Scale: 1:50	Date: JUNE 2006
Drawn By:	Checked By:
Client: MR P. MERRINGTON & MR S. SHAW	
Project: BARN CONVERSION	
Location: LOWER DIGLEA FARM BARN BOAT LANE DIGGLE	
Local Authority: OLDHAM	
1ST FLOOR BOURGHOUGH MILL NIELD STREET OLDHAM, OL8 1QG Tel : 0161 633 0484 Fax : 0161 633 0484 Web site <a href="http://www.plans.uk.com">www.plans.uk.com</a> e-mail <a href="mailto:info@plans.uk.com">info@plans.uk.com</a>	
Job Number:	Revision: E

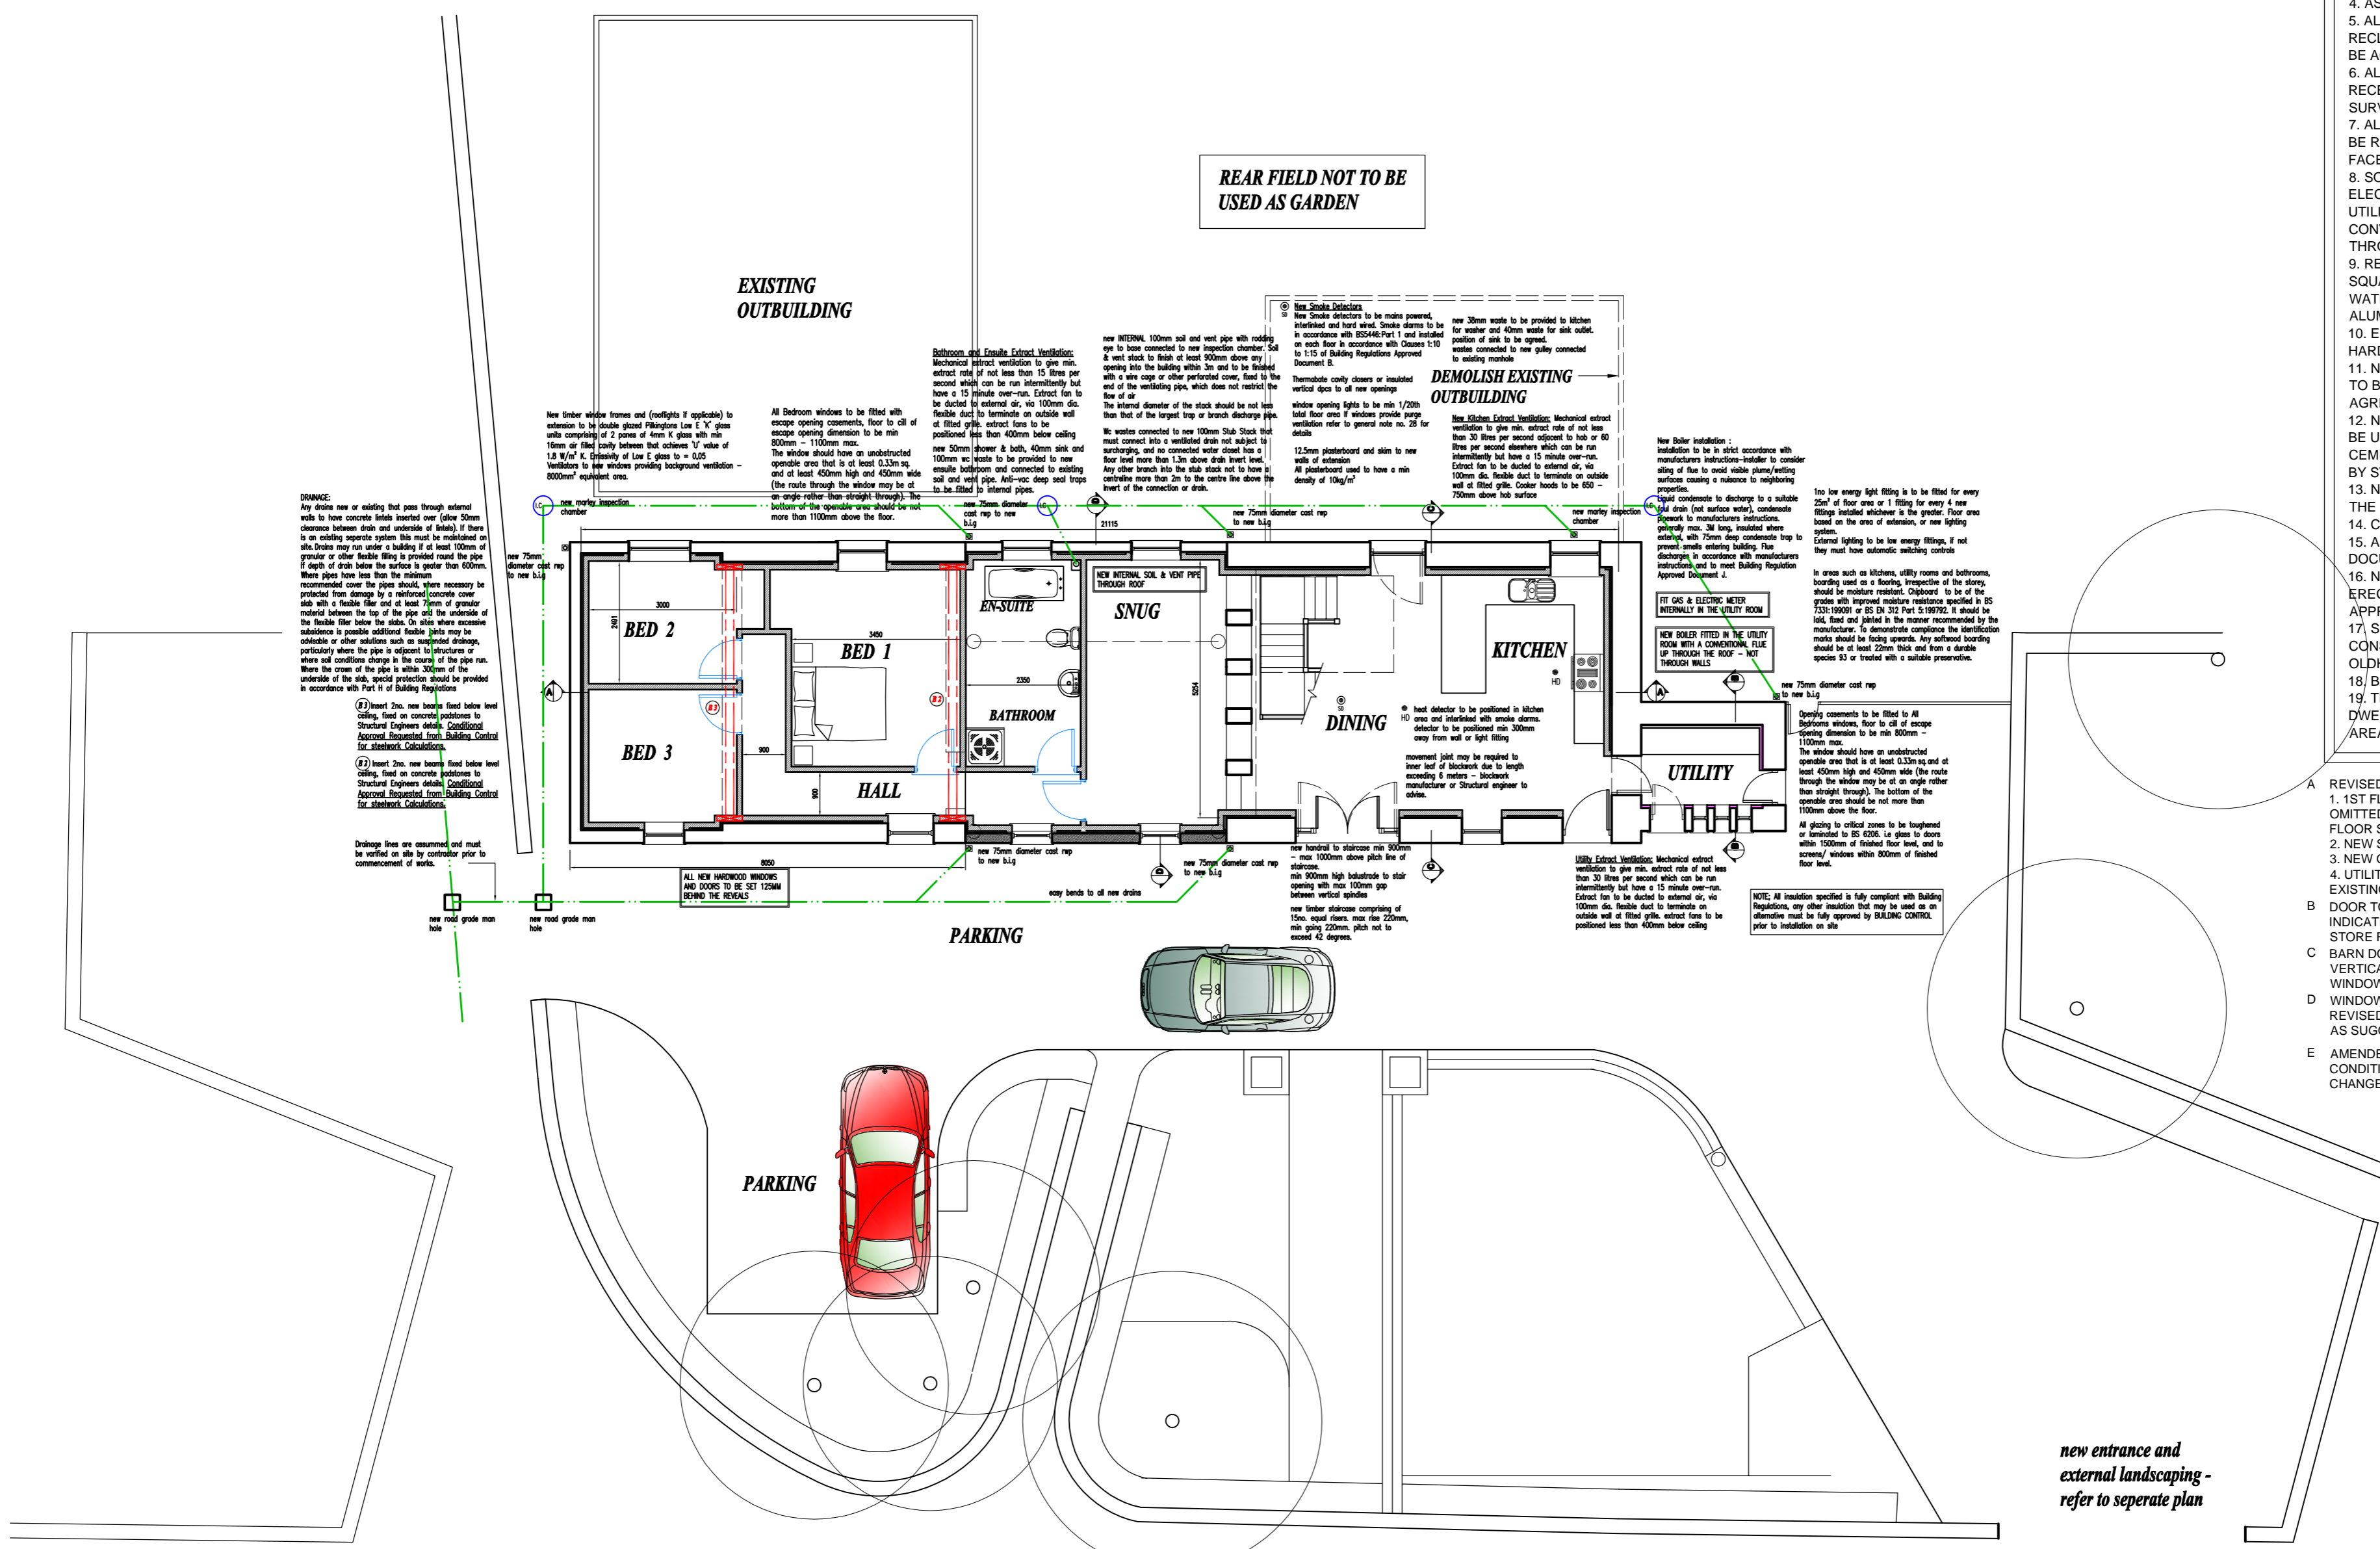
- A REVISED IN ACCORDANCE WITH PLANNERS COMMENTS
1. 1ST FLOOR EXTENSION PREVIOUSLY SHOWN OMITTED AND NEW ROOF OVER DINING AT GROUND FLOOR SHOWN.
  2. NEW SITE ENTRANCE OMITTED.
  3. NEW GARAGES OMITTED.
  4. UTILITY PREVIOUSLY SHOWN, CHANGED BACK TO EXISTING STORE.
- B DOOR TO REAR OF BUILDING REMOVED AND GARDEN INDICATED TO FRONT OF BUILDING. STORE ROOM CHANGED TO BEDROOM
- C BARN DOORS TO FRONT ELEVATION INDICATED. VERTICAL CENTRAL MULLIONS REMOVED TO ALL WINDOWS AS REQUESTED BY PLANNING OFFICER
- D WINDOWS AT 1ST FLOOR LEVEL TO FRONT ELEVATION REVISED. CONSERVATION VELUX WINDOWS INDICATED AS SUGGESTED BY PLANNING OFFICER.
- E AMENDED FOR BUILDING REGULATIONS - PLANNING CONDITIONS ADDED - INTERNAL ARRANGEMENT CHANGED - EXTERNAL DESIGN ADDED
